RAI Volume 2, Chapter 2.1.2, First Set, Number 1:

Provide a monitoring plan for the ground support system that explains what will be monitored, frequency of monitoring, criteria for selecting drifts to be monitored, spatial frequency of measurements within the drift, and the technical approach for processing information collected through monitoring to assess the performance of the ground support system and the need for maintenance to ensure access to waste packages through the preclosure period.

1. RESPONSE

Figure 4. Typical Installation for Emplacement Drift Wall Scanning Instrument when Mounted on Inspection Vehicle Concept Shown in Figure 3, Demonstrating Drift Wall Coverage from a Single Location.

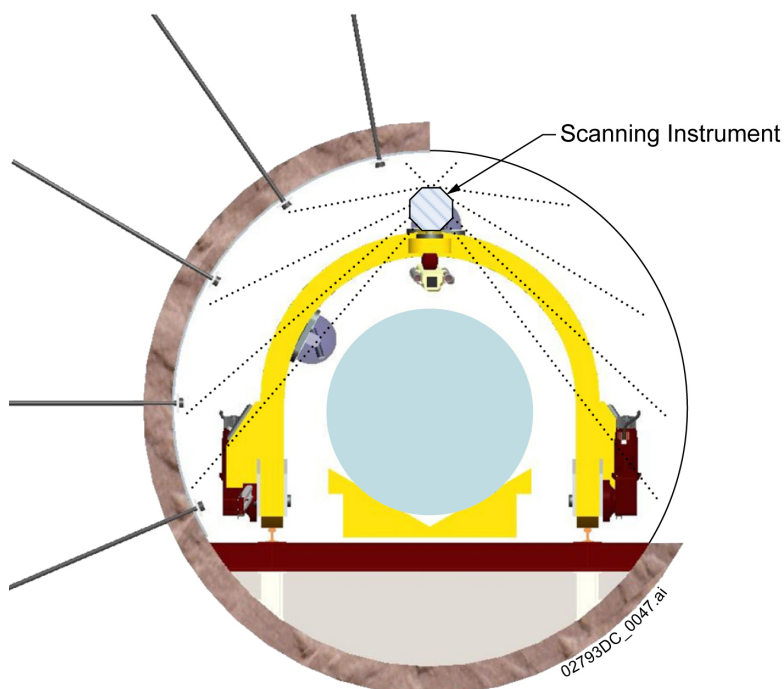
- (1) If the initial frequency of monitoring is reduced over time, would DOE notify the NRC and will a basis for the reduction be provided?
- (2) What are the criteria for selecting drifts to be monitored, or will all the drifts be monitored?
- (3) Clarify monitoring entire length of a drift versus spatial frequency of monitoring.
- (4) Explain how DOE is taking into account the physical environment in which convergence measurements will be taken so that there are no obstructions, and that the effects of high temperature and high radiation do not affect the instrumentation.

Convergence measurements will be based on individual drift wall readings taken at locations around the periphery of the drift above the invert structure, and processed electronically for diametrically opposed locations to determine convergence. DOE has considered the physical environment in which convergence measurements must be taken. Physical interference, if any,

from the waste package or pallet in the “line of sight” between opposing locations is not an impediment because each point in a drift cross-section is read independently from the other points. The spatial relationship of one point (i.e., distance) to other points is established through triangulation from a known reference point or a known reference trajectory (i.e., sensor readings from a fixed sensor location or sensor readings from a sensor taken from different locations along the trajectory of the gantry sensor platform that follows the drift periphery). Sensors on the inspection gantry (Figure 4) have access to any location on the drift periphery above the invert structure. Video cameras and other instrumentation in the inspection gantry will be qualified for their intended functions in the emplacement drift environment, and will be inspected, tested, and replaced, as needed, to maintain their functionality under the temperature, radiation, and other environmental conditions in the emplacement drifts.
